Section 12A Application No. Y/I-DB/2
To Amend Discovery Bay Outline Zoning Plan
For rezoning the permissible use from staff quarters to flats
At Area 6f, Discovery Bay

Response to Comments
October 2016

**Section 12A Application No.Y/I-DB/2
For rezoning the permissible use from staff quarters to flats at Area 6f, Discovery Bay
Response to Comments**

Section 12A Application No.Y/I-DB/2 for rezoning the permissible use from staff quarters to flats at Area 6f
 Applicant's response to the departmental comments made available by District Planning Office on 25 and 28 July 2016

AREA 6f
PROPOSED RESIDENTIAL DEVELOPMENT - Concept Plan

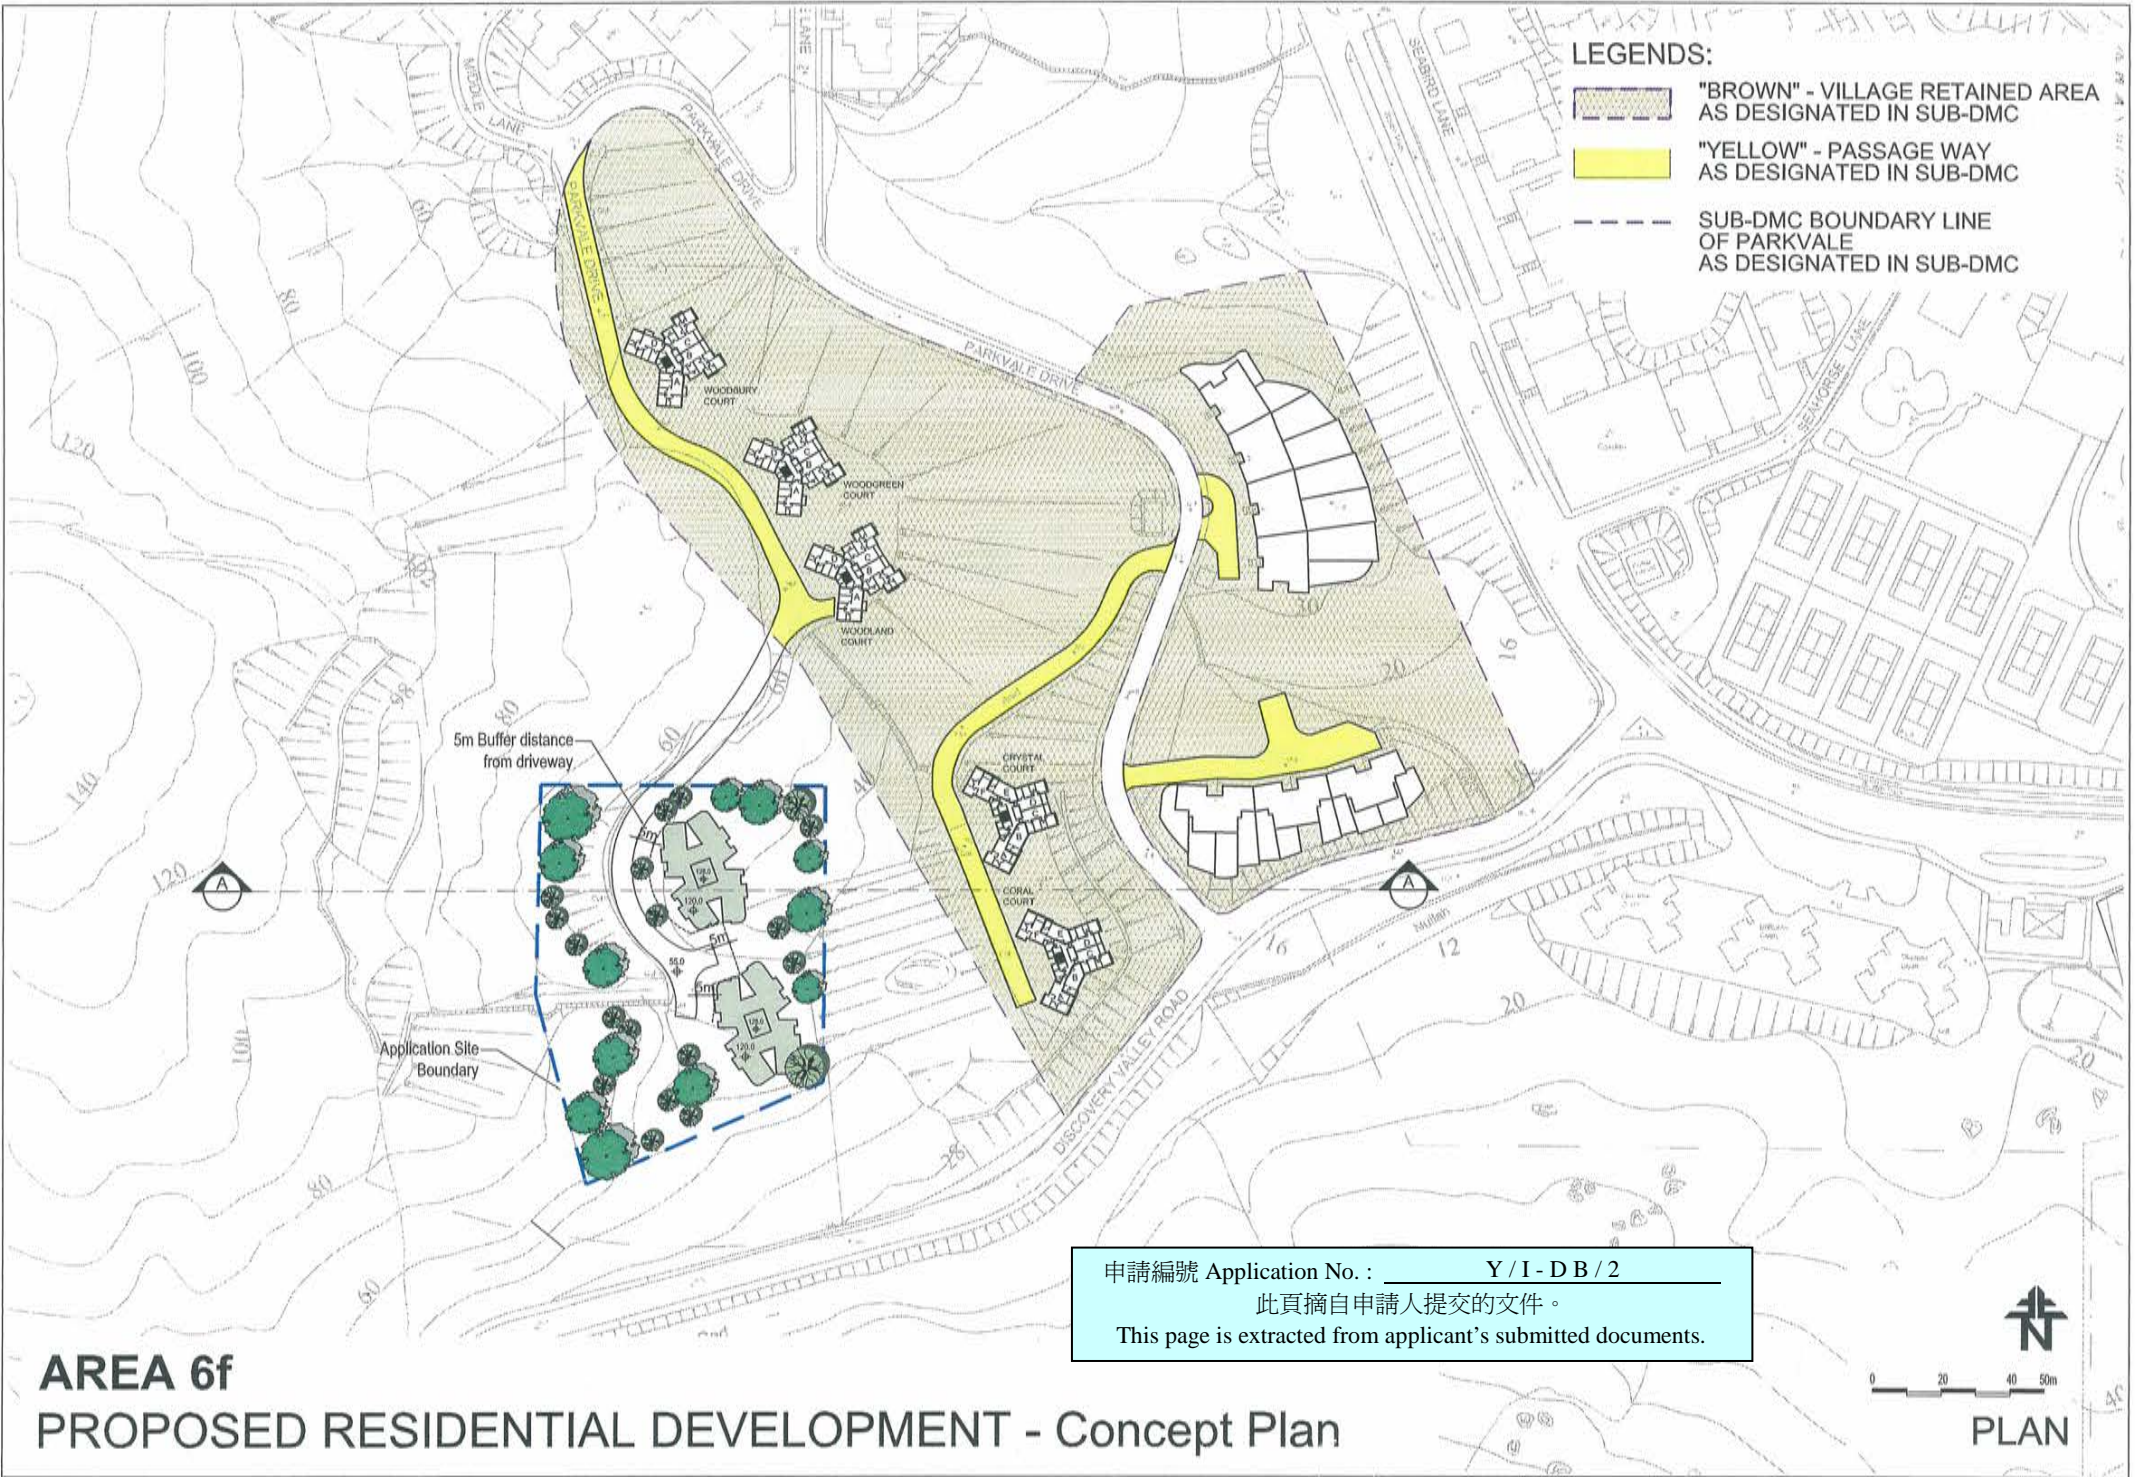
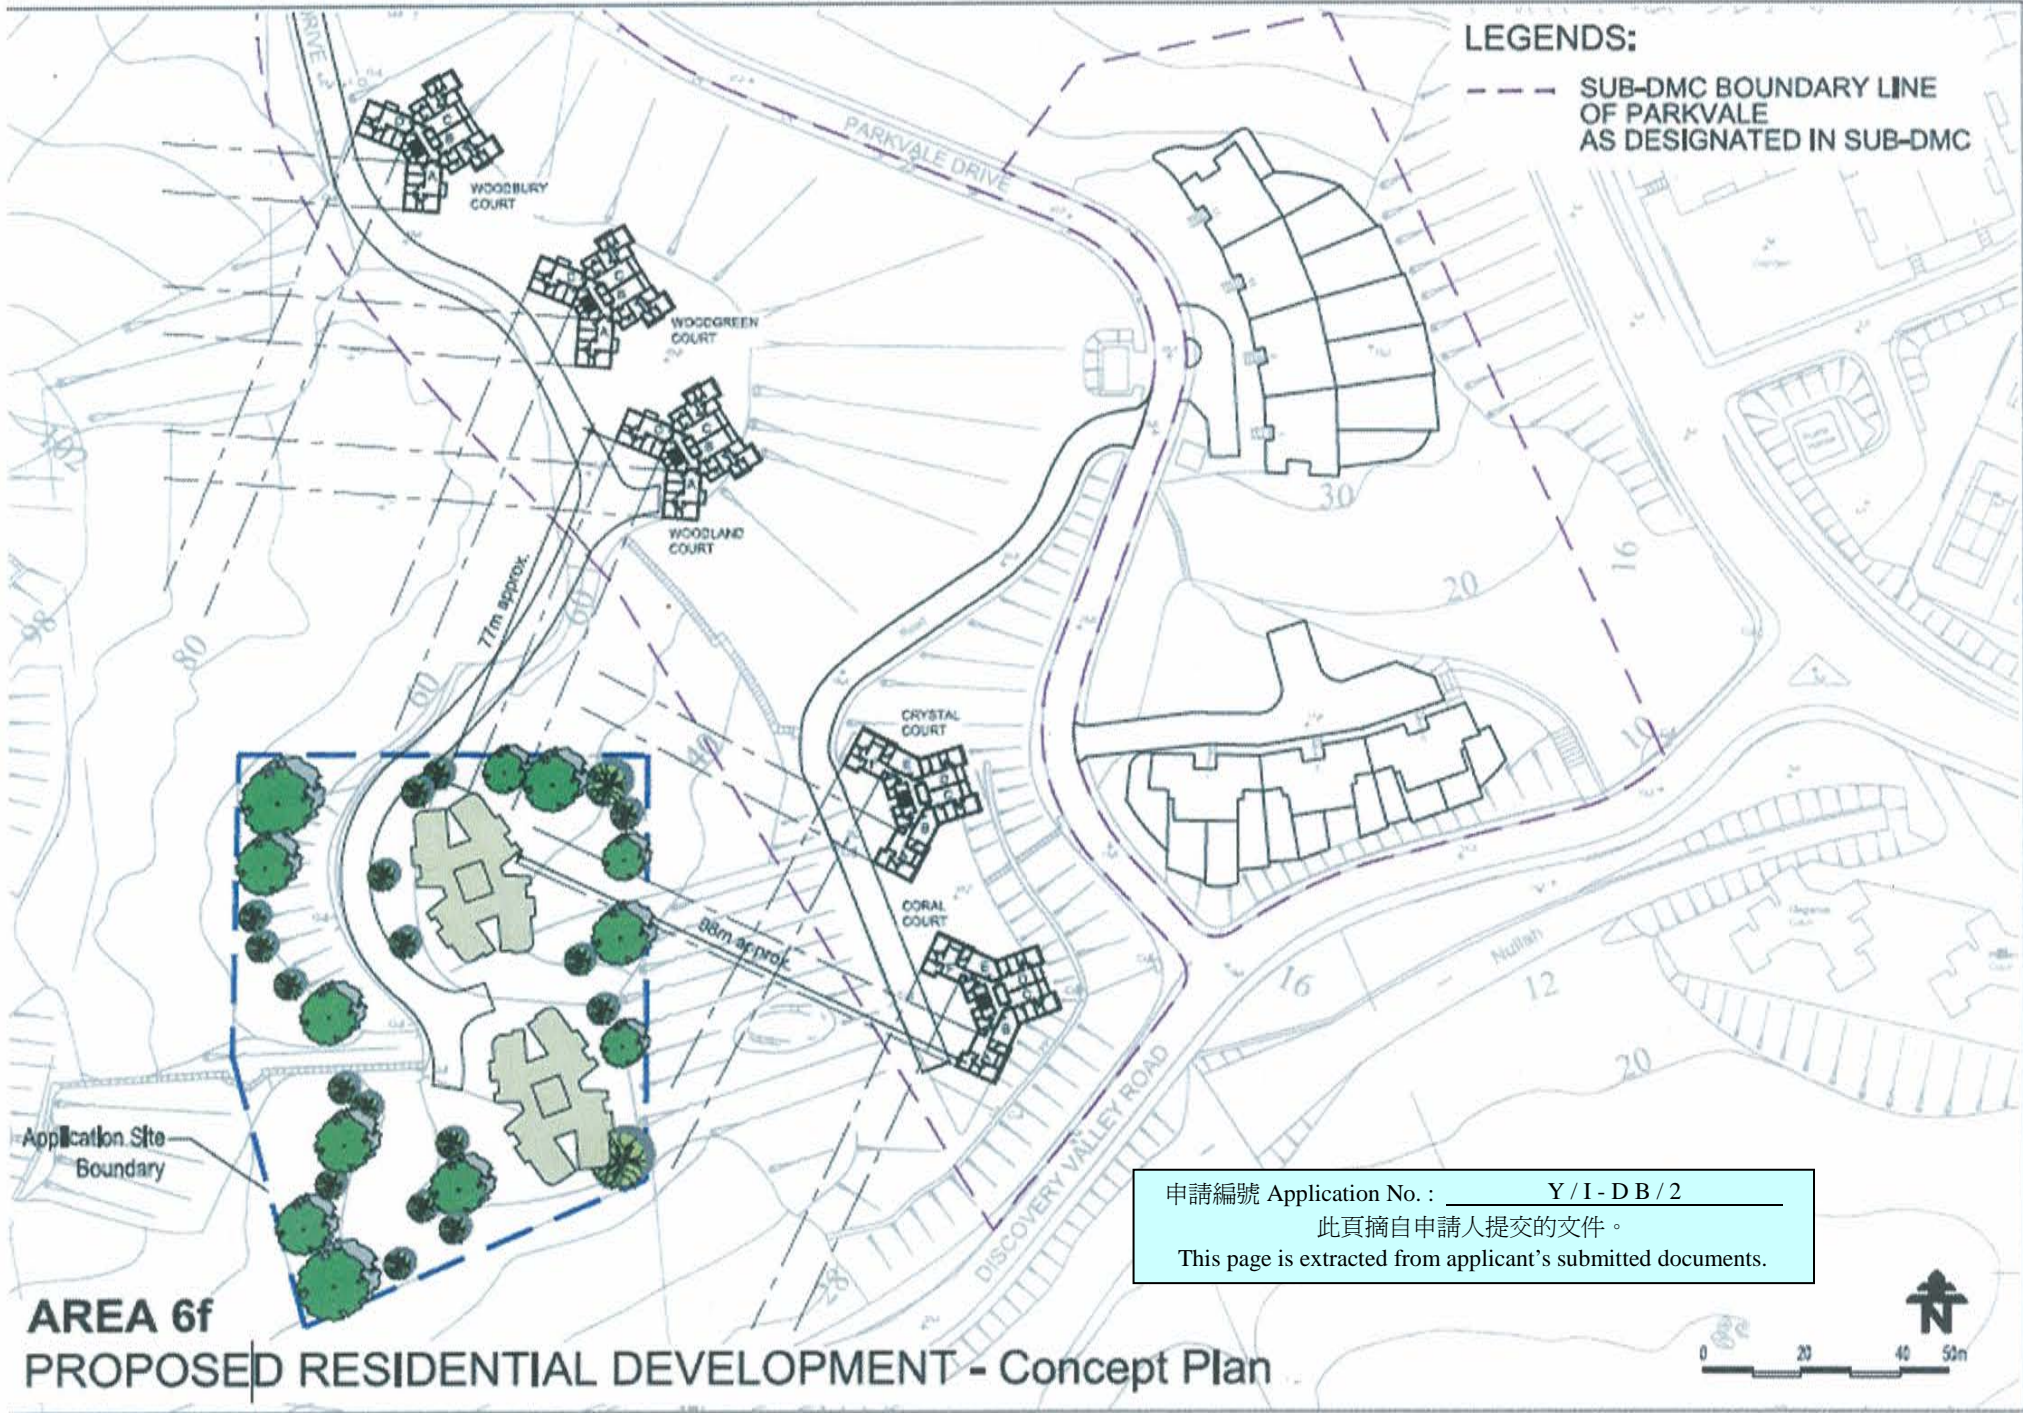
Revised Concept Plan

The Concept Plan has been revised to contain minor adjustments to the building disposition in relation to the access road to address departmental comments. The adjustments will not have significant impact on the findings in the original submission. Specifically, please find the photomontages for the revised scheme in **Annex H**, showing the negligible effect and that the previously submitted Visual Impact Assessment remains relevant.

<p>C. Sewerage Infrastructure</p> <p>Please note that our previous comments are still valid. The applicant should provide adequate information and make adequate rectifications in the submission to address our comments.</p>	<p>Please refer to the above response to comment items (5), (6) and (7) on water quality.</p>
<p>D. Air Quality</p>	
<p>1. <u>Rtc item c</u> Please mark the internal access road on the map.</p>	<p>Noted. Internal access road has been marked on Figure 4-1.</p>
<p>2. <u>Rtc item d and S4.2.2.4</u> If Parkvale Drive is a LD, please ensure that buffer distance requirement under HKPSG has been met. In the response, it mentioned that the residential premises will be located at least 5m above the ground level. Please be reminded that according to HKPSG the buffer distance should be the horizontal distance instead of vertical or slant distance. Please revise.</p>	<p>Noted. At least 5m buffer distance has been provided to ensure compliance of HKPSG's requirement, as shown in the revised Concept Plan in Annex A of this response submission.</p>
